PCN No.	PCN03058	PCN Date	11/9/2022	Effective Date	4/25/2022
Title	BGA Tray Change from UBOT to Hwa Shu

Type: Major

Product and Process Change Notice

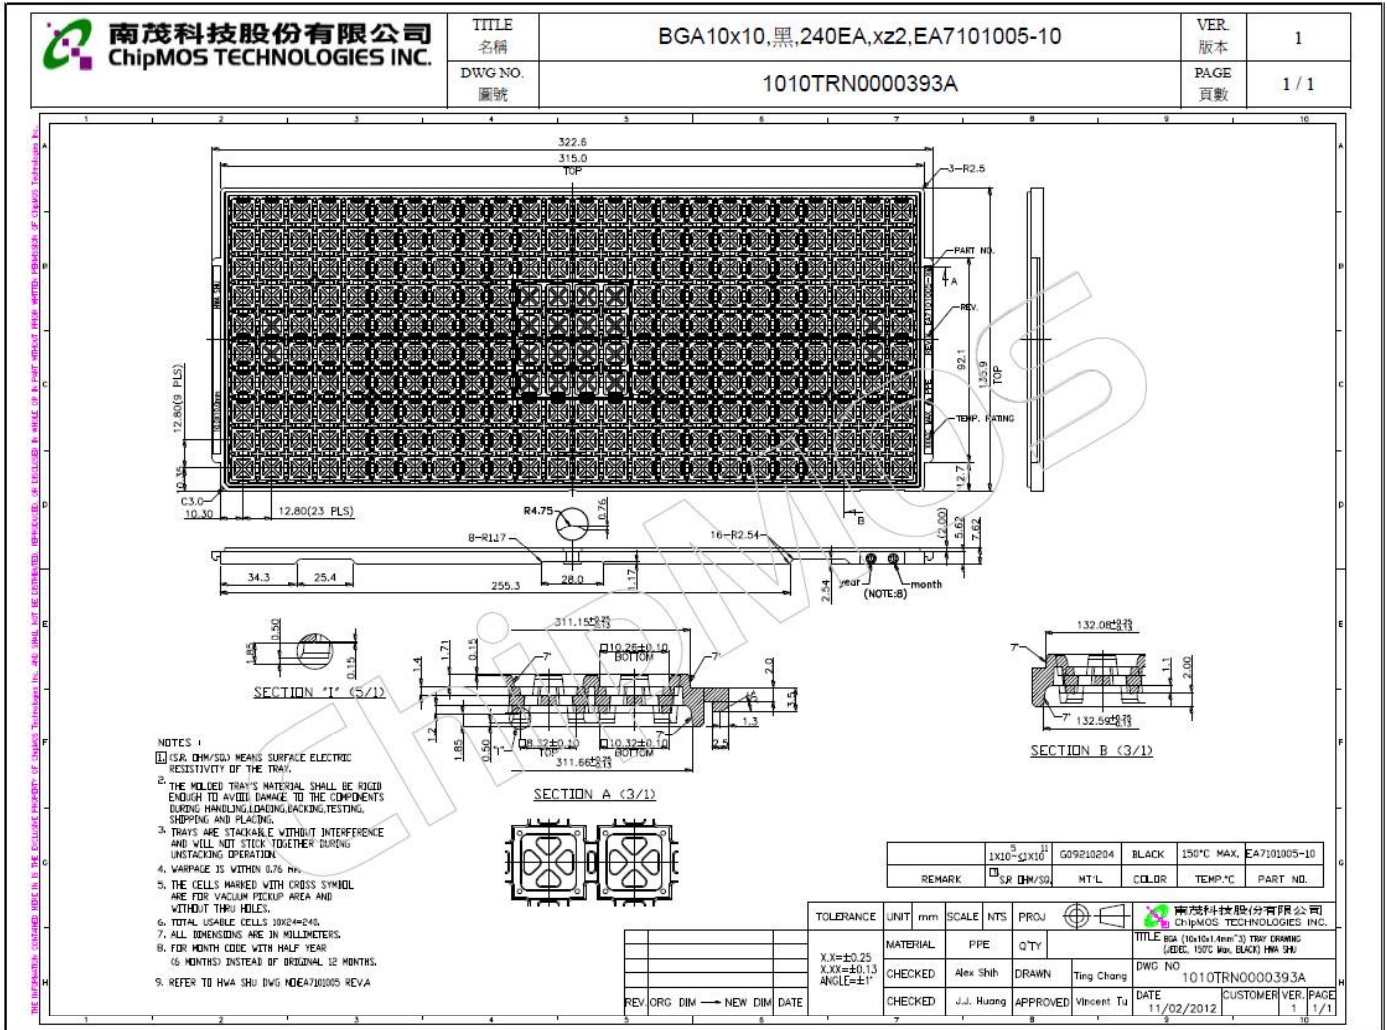
Impacts tray dimensions/configuration for packaging medium.

Hwa Shu Dimensions –(New) BGA TRAY 10 x 10mm 240 10 x 24 10mm-10x24 See attached below (JEDEC)

Ubot BGA Tray Dimensions – (old) 10x10 184 1.5x8x23 See attached below (JEDEC)
